25 January 1990

SUBJECT: DECISION ON THE SUITABILITY OF DREDGED MATERIAL TESTED UNDER PSDDA CRITERIA FOR THE METRO EMERGENCY BYPASS OUTFALL PROJECT (WEST POINT TREATMENT PLANT)(OYB-2-013039) TO BE DISPOSED OF AT THE ELLIOTT BAY OPEN WATER DISPOSAL SITE.

RESULTS OF CHEMICAL ANALYSES EXCEEDING PSDDA GUIDELINES: METRO EMERGENCY BYPASS OUTFALL PROJECT (OYB-2-012941)\*

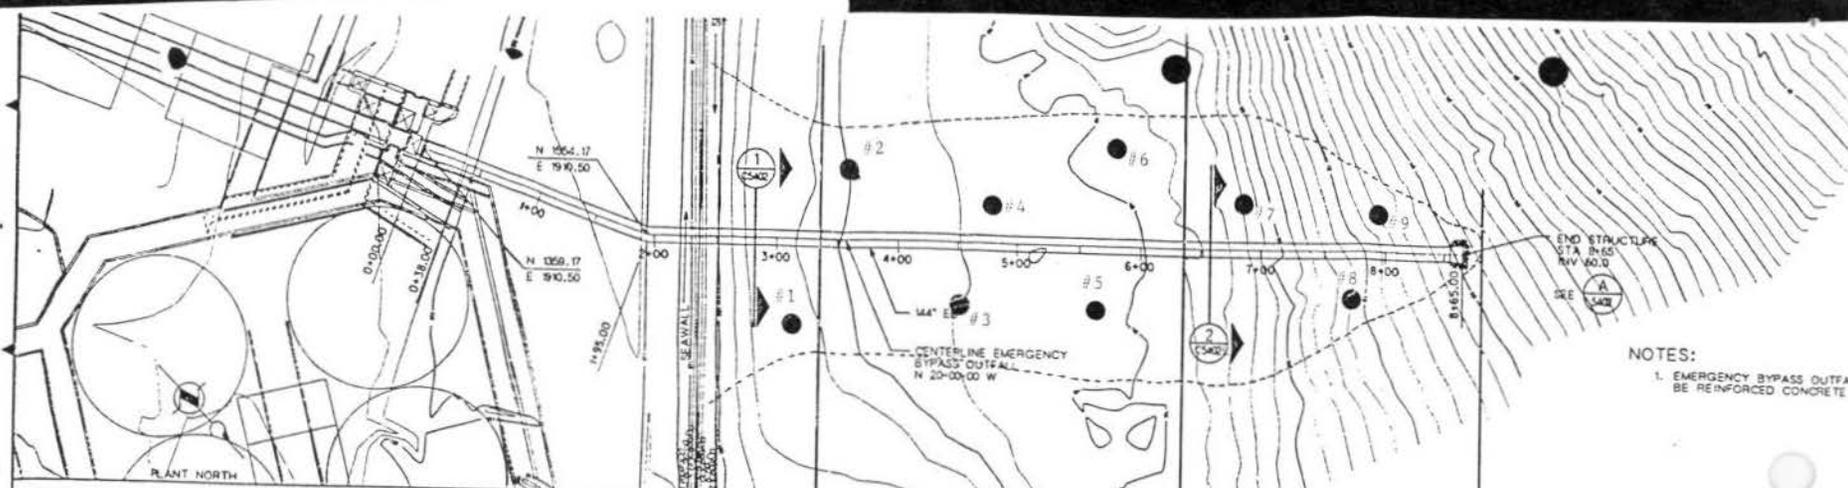
3. Four uncomposited surface samples and three composited subsurface samples (each consisting of three samples) were required under the PSDDA guidelines to chemically characterize the "high" concern area covered by the proposed project. Results of chemistry analyses depicting exceedences of PSDDA screening level (SL) guidelines are depicted in enclosure 1. Twelve individual chemicals of concern (COC) exceeded the PSDDA screening level (SL) (fourteen with including total LPAH and HPAH), although none exceeded the bioaccumulation trigger (BT) or maximum level (ML): all were LPAH's and HPAH's from the surface sample at station EBP-8. Detection limits for PSDDA were exceeded for seven COC (enclosure 1). Chemical characterization of the Samish Bay reference sample was also conducted, and generally supported its use as a reference sediment for bioassay comparisons. METRO opted to run bioassays concurrently with chemistry samples, and the results of these analyses are discussed below.

4. In summary, results for bioassay testing for the seven single/composited samples indicated that all dredged material management units passed the PSDDA interpretation guidelines. PSDDA interpretation guidelines specified in June 1988 EPTA, and Sediment Larvae bioassay interpretation guidelines clarified in the Phase II Management Plan Report (MPR) were used to evaluate the bioassay data. Interpretation guidelines discussed in the Phase II MPR specified necessary clarifications/changes in the Echinoderm embryo bioassay mortality and abnormality performance standards for control sediment, reference sediment, and dredged material relative to those specified in June 1988 EPTA. In general the Amphipod, Echinoderm embryo, and Microtox bioassays performed well with respect to appropriate control and reference sediment (Samish Bay) guidelines as specified by PSDDA. Reference sediment (i.e., Samish Bay) and control sediment (i.e., West Beach) performed well within PSDDA performance guidelines specified for each bioassay. All seven samples tested passed the amphipod bioassay and the saline microtox bioassay. Six of the seven sediment samples tested passed the echinoderm embryo bioassay (Dendraster excentricus) with a "single hit" (failure) being recorded for this bioassay for the

subsurface sample EBP-7-9. The tested sediment at EBP-7-9 (lower) was less than 20 percent absolute combined mortality/abnormality over reference sediment and was statistically different (t-Test,  $p < .05$ ), thereby requiring another bioassay "hit" to fail the dredged material management unit. There were no other bioassay "hits". Therefore, the results of these bioassays demonstrated that all seven samples passed the nondispersive disposal guidelines for unconfined openwater disposal.

5. Based on the above discussion and summary of chemical and bioassay results for the METRO Emergency Bypass Outfall Project area, the PSDDA agencies concluded that all the dredged material tested (48,775 cubic yards) is suitable for disposal at the Elliott Bay PSDDA disposal site.
